**Subject: Remedial Investigation Work Plan Addendum (No. 2) Modification  
Former Equity Works Manufactured Gas Plant (MGP) Site  
Brooklyn, New York  
NYSDEC Site No.: 224050, Order on Consent Index #: A2-0552-0606**

NATIONAL GRID EQUITY FORMER MGP SITE, BROOKLYN NY 60137362-400		<b>RECOMMENDED REMEDIAL                  INVESTIGATION ADDENDUM LOCATIONS</b>
DATE: 05/06/2013	DRWN: BcV/C-MA	<b>FIGURE - 1A</b>

# **Remedial Investigation Work Plan Addendum (No. 2)**

**FIGURE - 1**

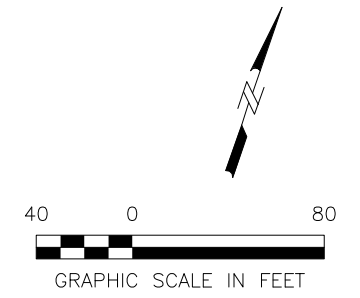
Remedial investigation locations completed to date, proposed soil borings, proposed monitoring well locations, and proposed contingency locations are shown on Figure 1. The rationale and sampling analysis summary for each proposed boring and monitoring well is included on Table 1. All work will be performed in accordance with the procedures specified in the 2009 NYSDEC Approved RI Work Plan except where noted below.

In general, the target completion criteria for soil borings SB-25, SB-26, SB-27, SB-28, SB-31, and SB-32 will be contact with the Gardiner's Clay and/or 10 feet into visually clean material. If impacts are not observed within 10 ft of the Gardiner's Clay, the boring will be terminated at the Gardiner's Clay surface. The anticipated completion depth for these soil borings is approximately 105 feet (Table 1). The anticipated completion depth of boring SB-20 is 140 ft bgs. The purpose of SB-20 is to determine the soil and groundwater quality below the surface of the Gardiner's Clay. The final completion depth of boring SB-20 will be approximately ten feet into the Jameco Gravel. However, the thickness of the Gardiner's Clay ranges from a few feet to over 200 ft. Therefore, if the SB-20 boring is advanced approximately 50 ft or more into the Gardiner's Clay, a point at which migration of constituents across the extremely low porosity clay to the Jameco Gravel would be considered highly unlikely, the SB-20 boring may be terminated.

Tier I and Tier II borings will be advanced contingent on the observations and measurements following the advancement of the Remedial Investigation Addendum No. 2 Locations and in consultation with NYSDEC. The borings will be advanced in accordance with the methods specified above, and target depths will be selected based on observations at adjacent borings. All contingency locations will be cleared using geophysical techniques during the initial pre-clearing activities to allow access to these locations during the same mobilization. Borings may be converted to monitoring wells if required, and following consultation with NYSDEC.
